Technical Service Bulletin: TSB170124

Fuel Pump Timing Correction to Reduce Engine Noise

Figure 1. Service Tool Installation on ISX/QSX CM2250, CM2350, and X15 CM2350 114B.

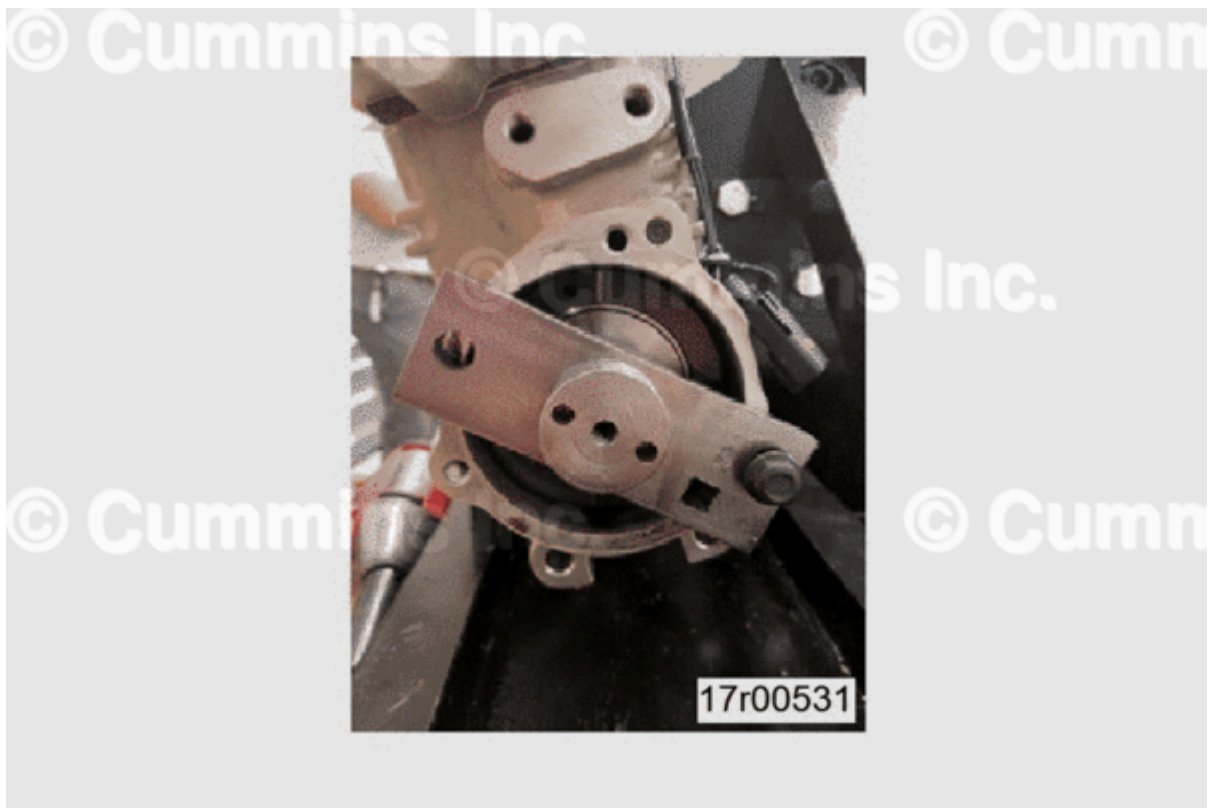
A new fuel pump timing gauge has been released for service. The following steps refer to the updated service documentation to follow so the fuel pump is timed correctly with the engine. Performing the steps below will help reduce engine noise.

See Figures 1 and 2 for descriptions of tools installed on fuel pump(s).
